**Re: West ABQ Self Storage
99999 Woodmont NW (Paseo Del Norte & Woodmont)
Conceptual Traffic Circulation Layout for DFT Approval
Engineer's Stamp 8-1-25 (C09D022) TRANS-2025-00212**

SITE PLAN EXHIBIT

WEST ABQ SELF STORAGE

DRAWN BY: JCM	DATE: 08/2025
CHECKED BY: NP	BHJ PROJECT NO: 20250389 SHEET NO: C-001

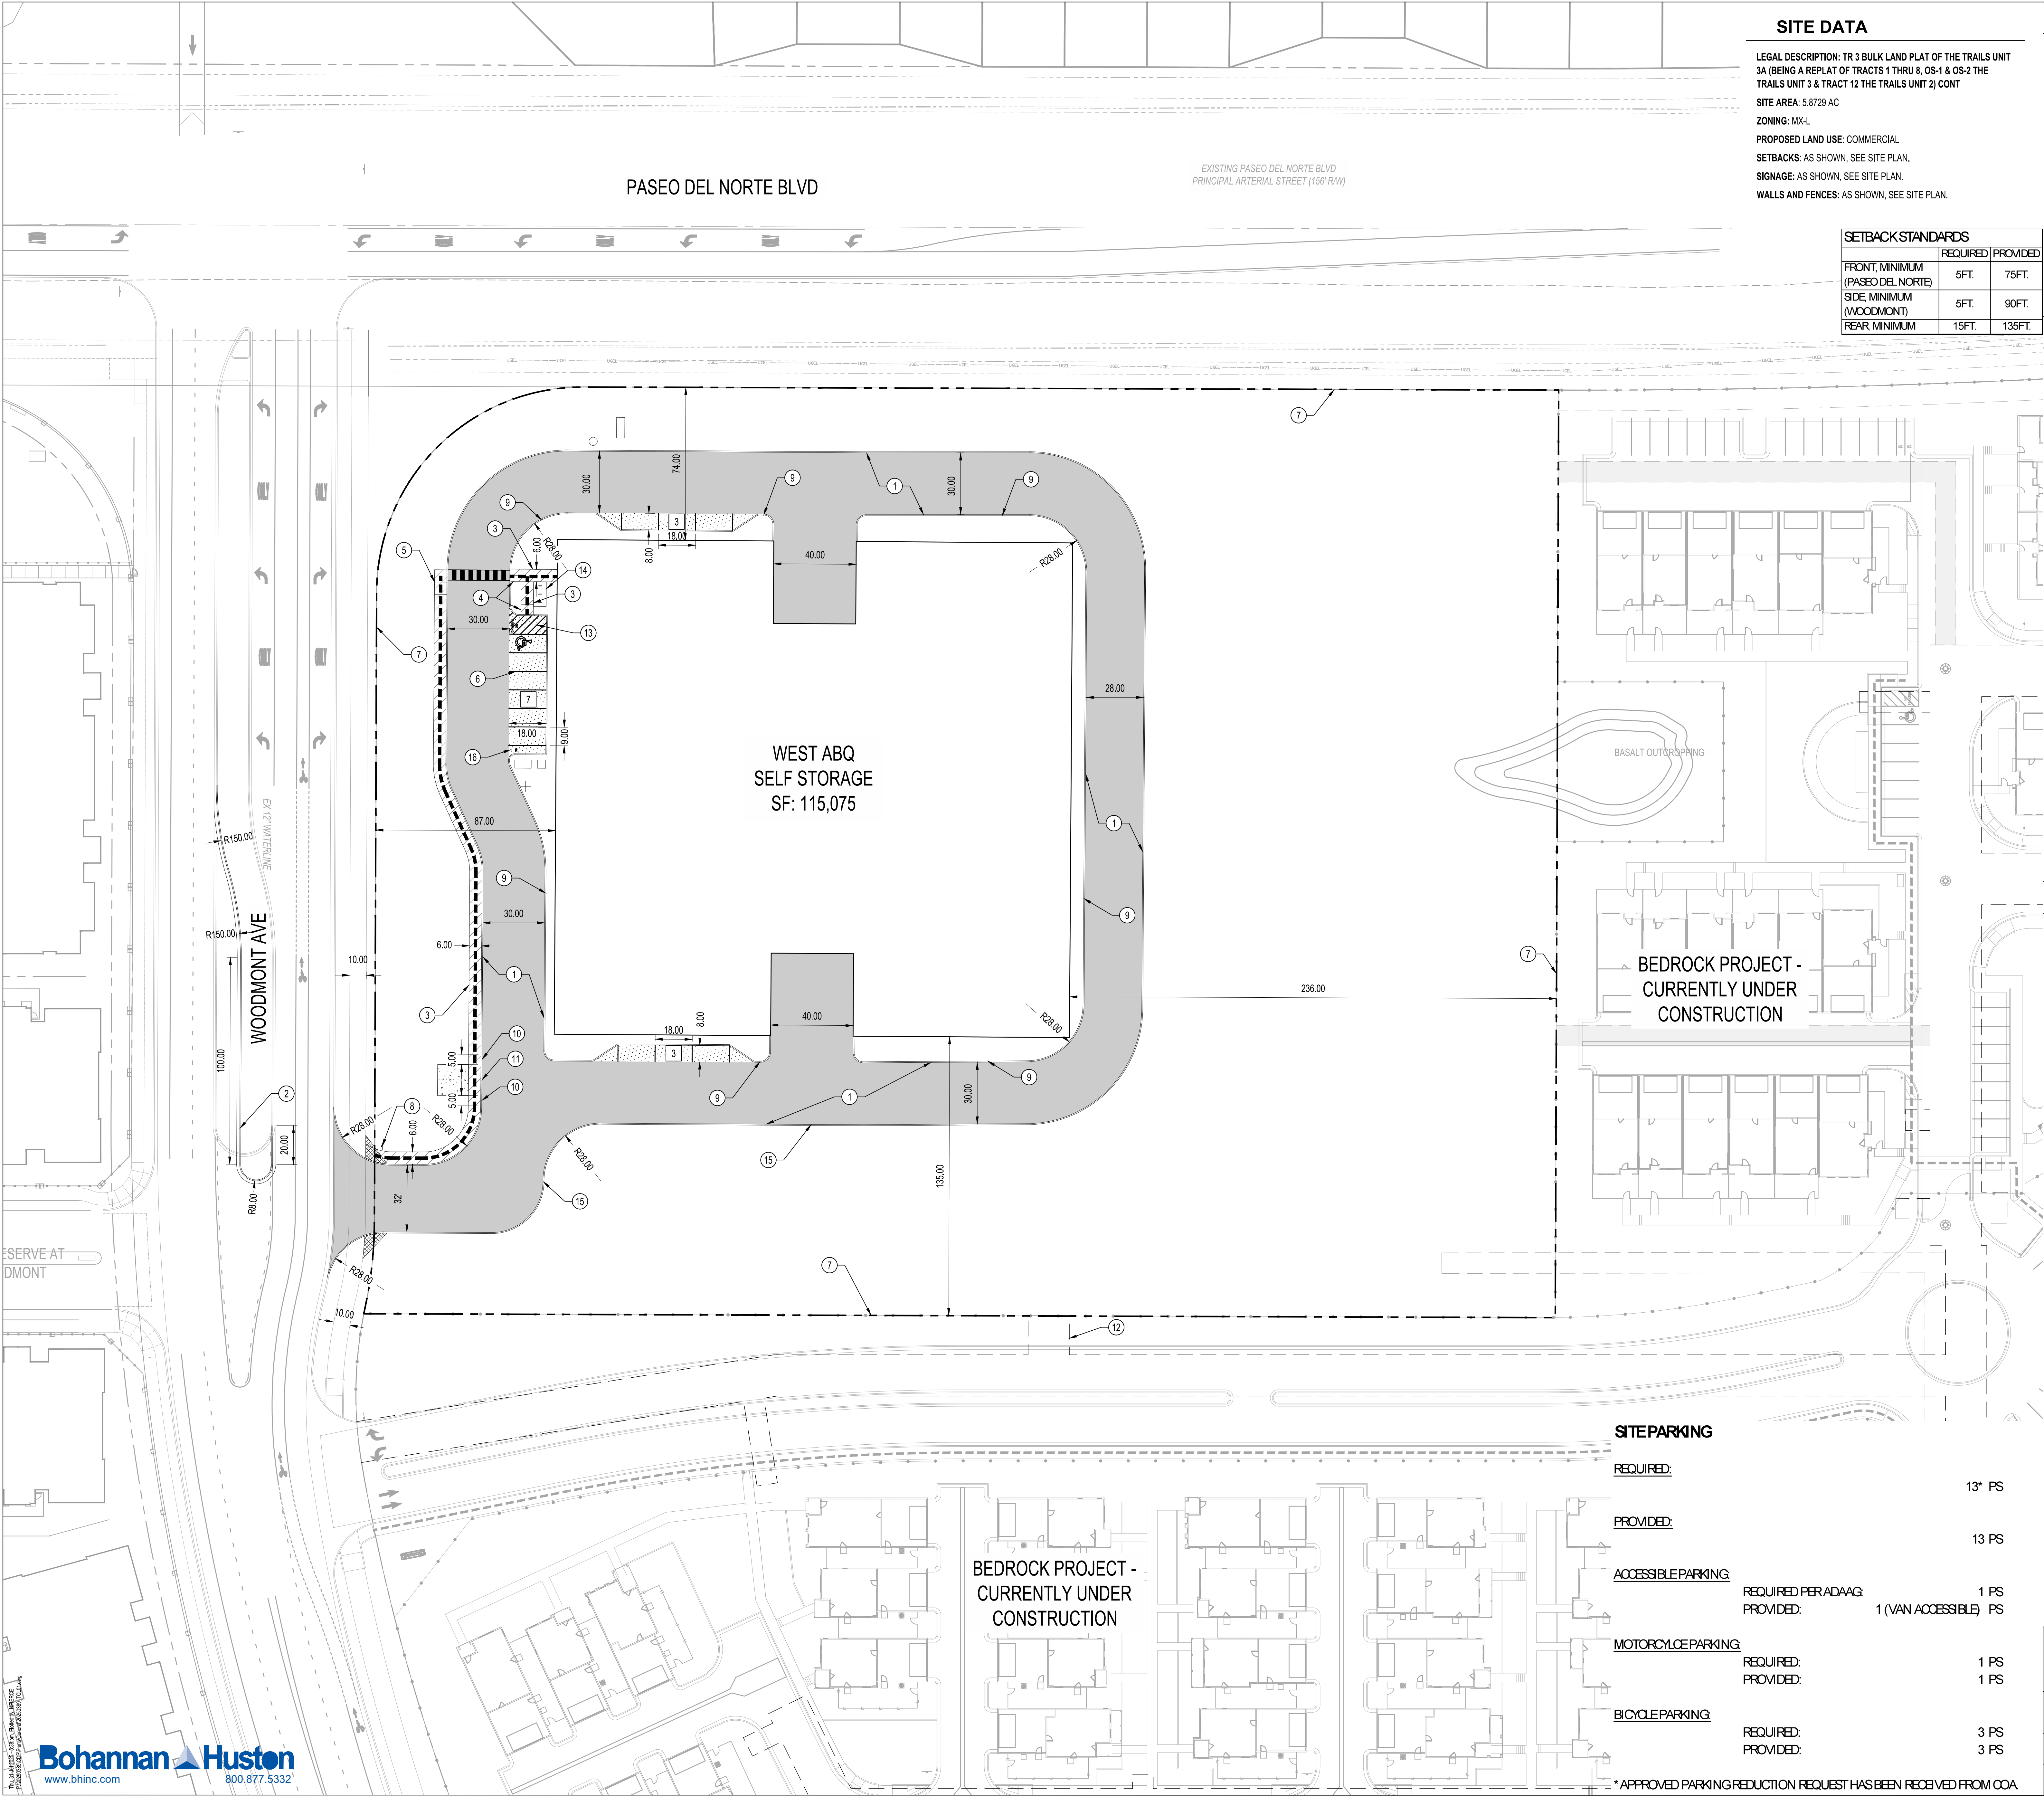
1-A 6 ft sidewalk, and 5-6 ft Landscape/Buffer along Paseo Del Norte is shown on the TCL plan

2- A 5 ft sidewalk, and 4-6 ft Landscape/Buffer along Woodmonte is shown on the TCL plan
3- A 5 ft sidewalk, and 4-6 ft Landscape/Buffer along Unnamed road on the south is shown on the TCL plan.

4-All the above infrastructures should be added to the IIA list and financially guaranteed.
